ROAD DESIGN MANUAL REVISIONS
January, 2016

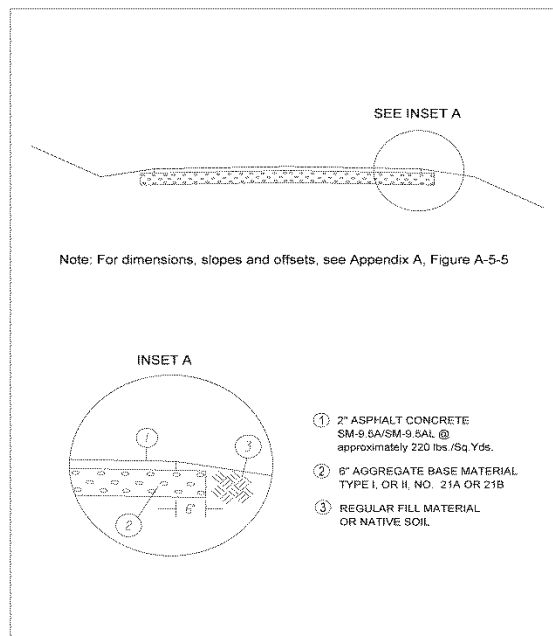
- Page 2G-19 – Revised the following language in the first paragraph under “ROADSIDE DEVELOPMENT” from; *“Quantities relative to Roadside Development and Temporary Erosion and Sediment Control are summarized on the Roadside Development Sheet provided as a CADD file. This is a multi-purpose sheet providing types of seed mixtures, rates of application, and quantities. Quantities relative to temporary Erosion and Siltation Control shall be summarized on the Roadside Development Sheet, with the exception of any necessary outfall pipe, which will be summarized in the drainage summary.”* To; *Quantities relative to Roadside Development and Temporary Erosion and Sediment Control are summarized on the “appropriate” sheet provided as a CADD file.*

Added the following language to “FIGURE 15 – CURB EXTENSION DETAIL” to “FIGURE 15 – CURB EXTENSION “(BULB OUTS)” DETAIL”.

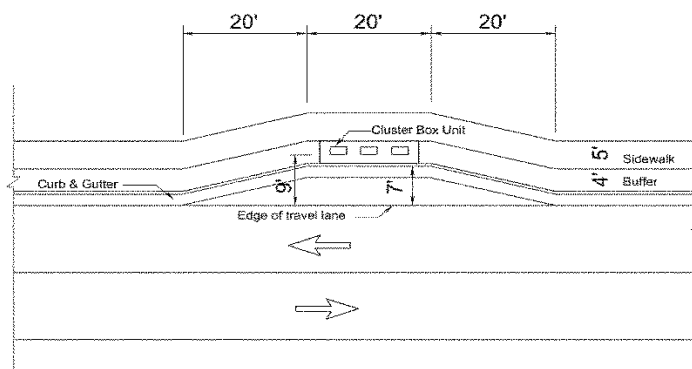
- Page B-45 – Revised the following language in the first sentence under item #7 Curb Extension to add “(Bulb-Outs)”

Detail for Cluster Box Unit Turnout

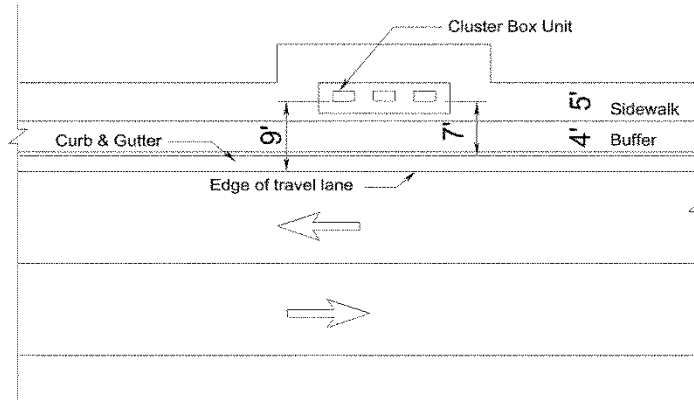
- Page B(1)-41 & 42 – Added the following language;
“Units (CBUs) may be required by the U.S. Postal Service in subdivisions. If so, the placement of CBUs will be restricted to subdivision streets with design speeds of 30 mph or less and shall be located outside the clear zone (7 feet minimum measured from the face of curb or 9 feet minimum from the edge of travel lane on a shoulder and ditch typical section).”

Contact your local USPS representative for USPS Approved Specifications for the Concrete Pad for Single or Multiple Units as well as the CBU orientation (access for USPS delivery and customer) relative to the roadway. CBUs shall be ADA accessible in accordance with IIM-LD-55 (Curb Ramps and Sidewalks). See Details for CBU Turnout and CBU Without Turnout below.”
